TECHNICAL SERVICE BULLETIN

REF.: ENGINE
 NO.: EN91-006
 DATE: MAY 24, 1991
 MODEL: MA/MX

FUEL LINE TORQUE SPECIFICATIONS

COMPONENT LOCATION:

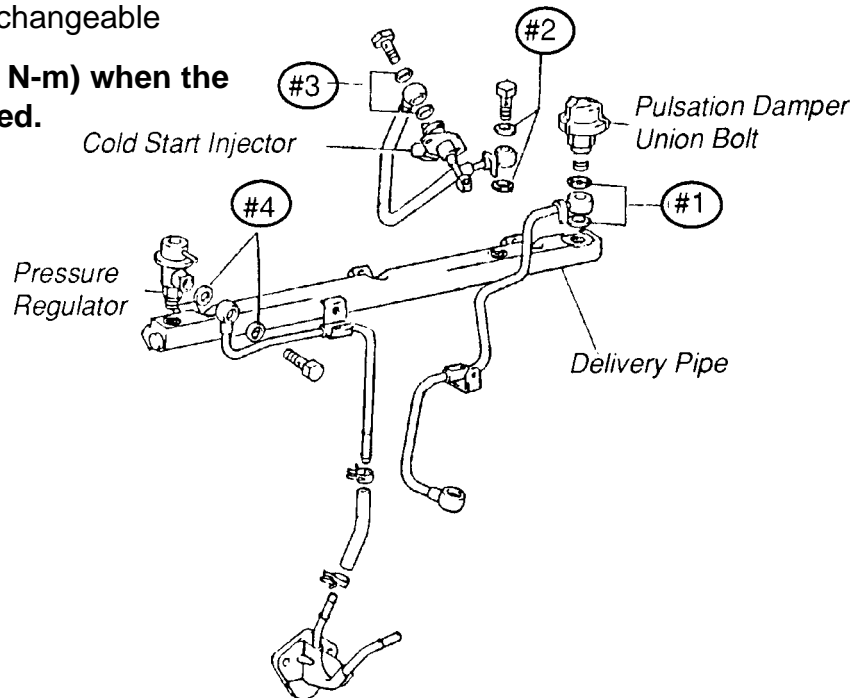
The fuel line torque specifications on 7M-GE and 7M-STE engines have been revised as the gasket material has changed from copper-plated to tin-plated. Torques for union bolts and pulsation damper are different depending on the type of gasket used.

GASKET LOCATION	PREVIOUS – COPPER PLATED		NEW GASKET – TIN PLATED	
	P/N	TORQUE	P/N	TORQUE
#1 UPPER LOWER	90430-17002 90430-14002	29 ft-lb (31 N-m)	90430-17006 90430-14007	* 23 ft-lb (31 N-m)
#2 UPPER LOWER	90430-12005 "	22 ft-lb (29 N-m)	90430-12026 "	23 ft-lb (31 N-m)
#3 UPPER LOWER	90430-08005 "	13 ft-lb (18 N-m)	90430-08012 "	8 ft-lb (11 N-m)
#4 UPPER LOWER	90430-10204 "	18 ft-lb (25 N-m)	90430-10012 "	18 ft-lb (25 N-m)

* Torque must be 20 ft-lb (26 N-m) when the pulsation damper is installed.
